AL NG911 System and Services RFP
AL-NG911-RFP-16-001
Addendum 1
Question and Answer Responses
2-19-2016

Appendix A – Additional PSAP and ANGEN Information

General Information

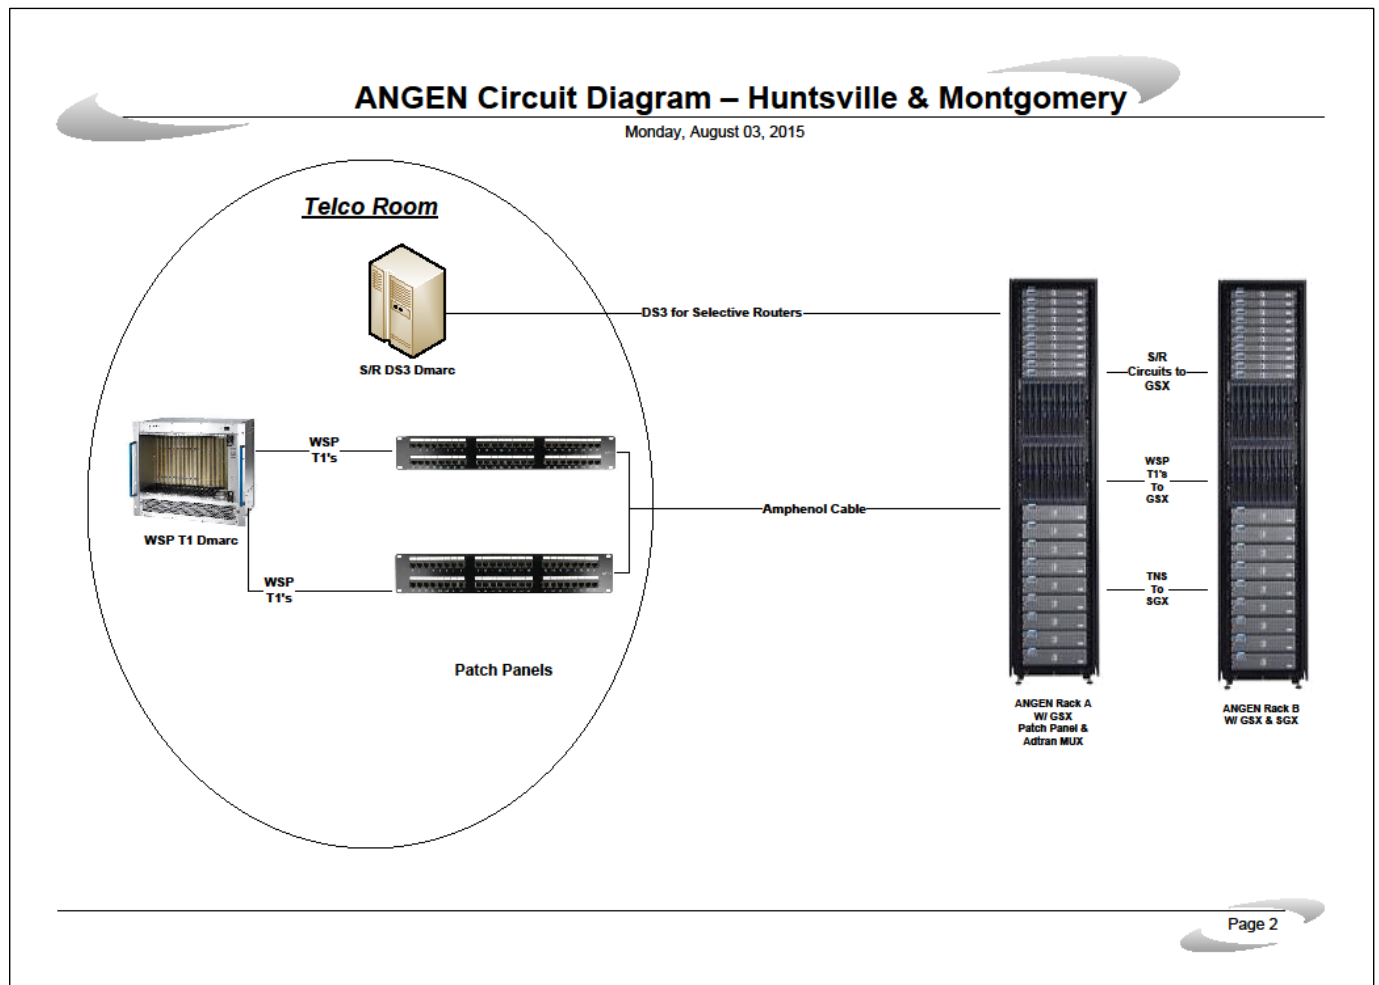
Any legal or regulatory agreements that may be required to facilitate or support the ability to transfer ANGEN traffic in state or to contiguous states will be the responsibility of the contracted service provider.
6	AL-NG9-1-1-RFP-16-001 ATTACHMENT D- Technical Specifications		Please inventory and detail the current equipment used at the wireless aggregation points? Please include make, model, software load and current maintenance provider and warranty (if any) information along with termination dates for maintenance and warranty	<p>Please refer to Appendix A of this document.</p> <p>The Board does not maintain this information.</p>
7	AL-NG9-1-1-RFP-16-001 ATTACHMENT D- Technical Specifications	6.1	What are the current SLA's being used in the ANGEN network operation?	There are no current SLAs to provide on behalf of the Board.
8	AL-NG9-1-1-RFP-16-001 ATTACHMENT D- Technical Specifications		Please provide the physical address of the two data centers	Please refer to Appendix A of this document.

9-1-1 calls arrive via SS7 on T1s and are routed to the seven legacy selective routers via the same.

Either core facility can handle the call volume for Alabama and this has occurred.

ANGEN assigned a primary and secondary core facility for each PSAP. The call load is reasonably balanced between the two facilities.

AT&T Wireless is the exception to the primary/secondary policy, AT&T routes calls from each MSC alternately between the two core facilities without regard for geography.
